July 31, 1981

During our review of the Three Mile Island Nuclear Station unit No. 1 (TMI-1) waste gas system several telephone conversations ensued with your staff regarding the Hydrogen/Oxygen monitoring system. In order to confirm the information provided in these telephone conversations we request that you respond to the questions listed in the enclosure for the record.

QUESTIONS ON CONTROL OF  
EXPLOSIVE GAS MIXTURES IN  
THE TMI-1 WASTE GAS SYSTEMS

Figure 1  
TMI-1 WASTE GAS SYSTEM

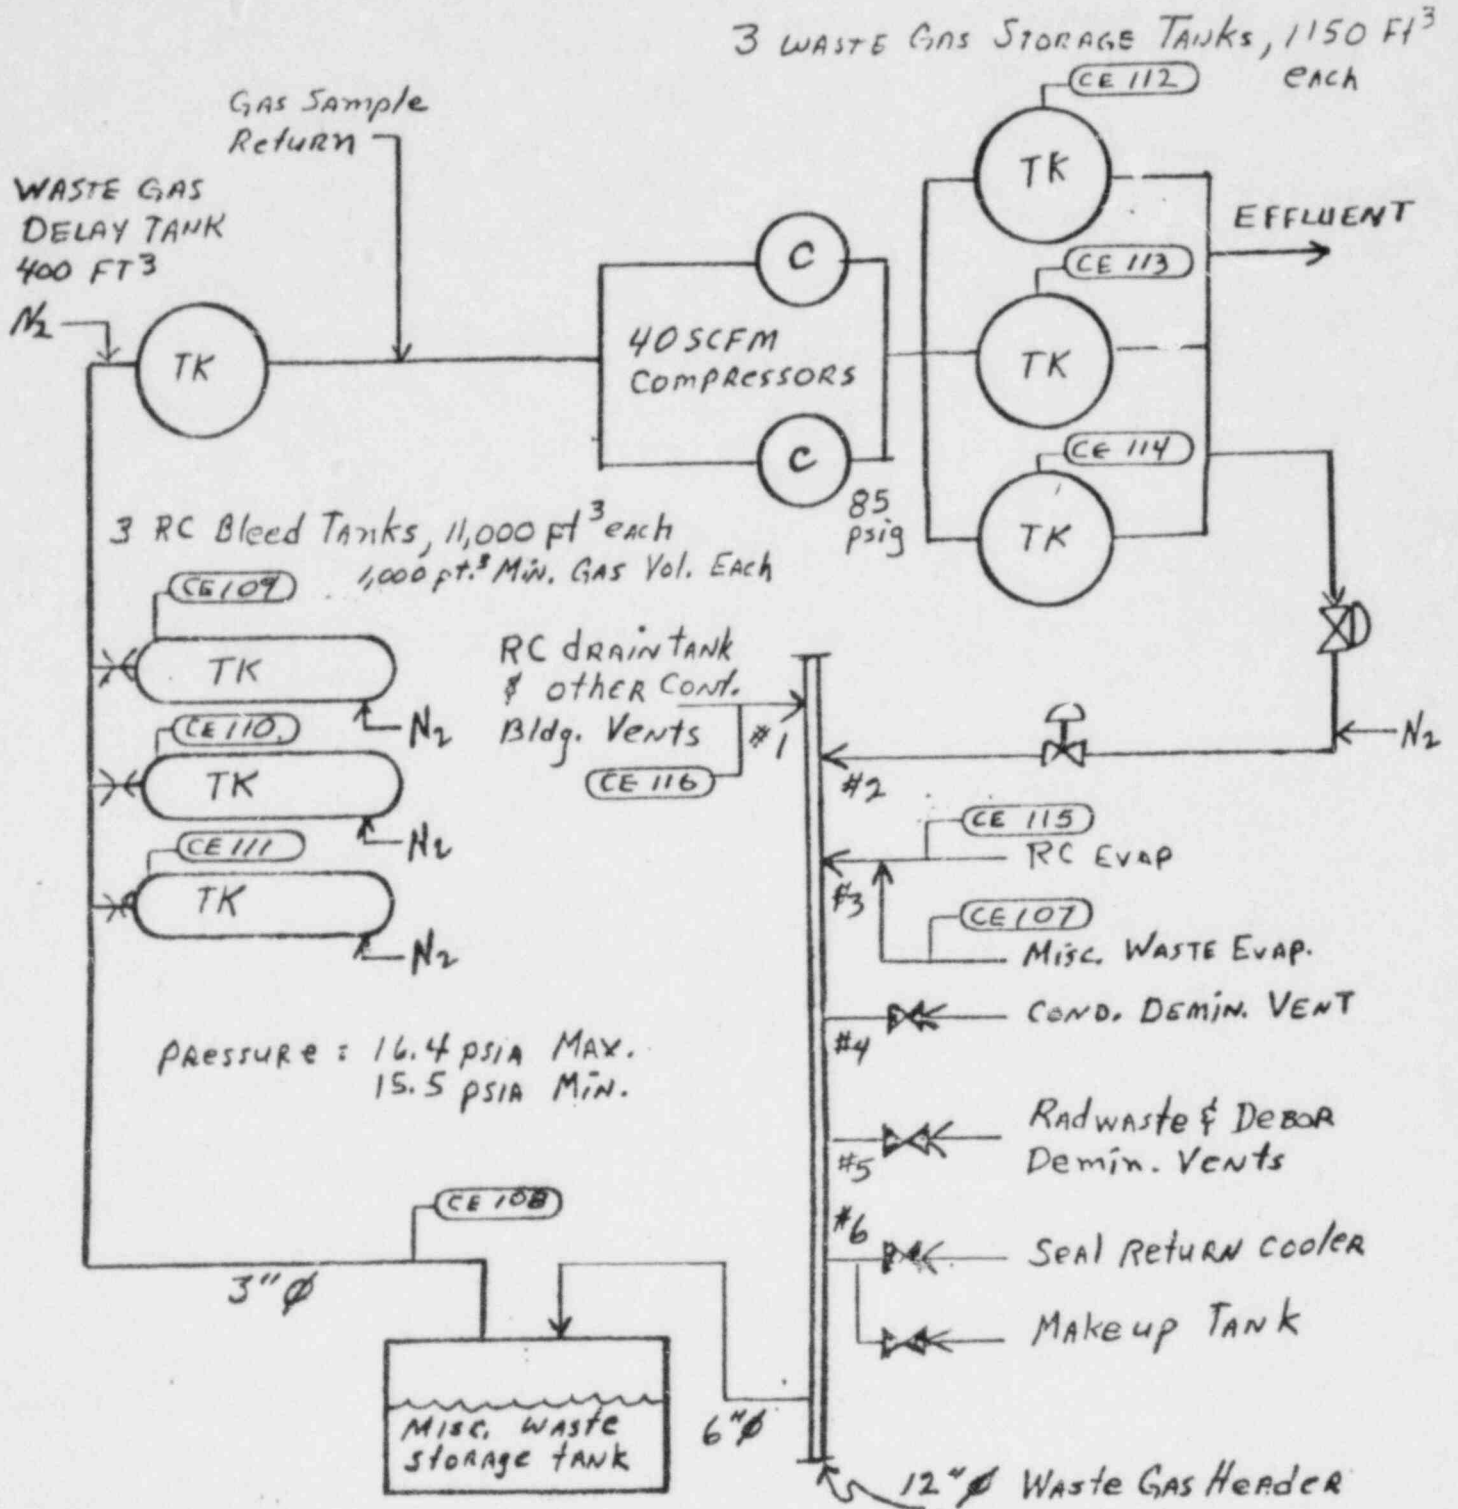
1. Are procedures in effect which require keeping waste gas concentrations below 3% H<sub>2</sub> and 0.1% O<sub>2</sub> by volume at each of the sampling points?
2. Is the waste gas system pressure controlled automatically so it stays between 15.5 and 16.4 psia?
3. Is N<sub>2</sub> constantly on supply to:
  - a) bleed tanks at MI-V17,
  - b) header at NI-V37,
  - c) waste gas delay tank,
  - d) compressors at NI-V23 & V24, and
  - e) makeup tank at NI-V22?
4. Is the sketch (Figure 1) of the waste gas system essentially correct?
5. During normal operation, is the principle source of H<sub>2</sub> letdown to the RC bleed tanks? Is this bleed no greater than 4000 gal/day?
6. When grab samples are necessary, will they be taken from the points where concentrations are most likely to be high, such as from CE-108 during degas?
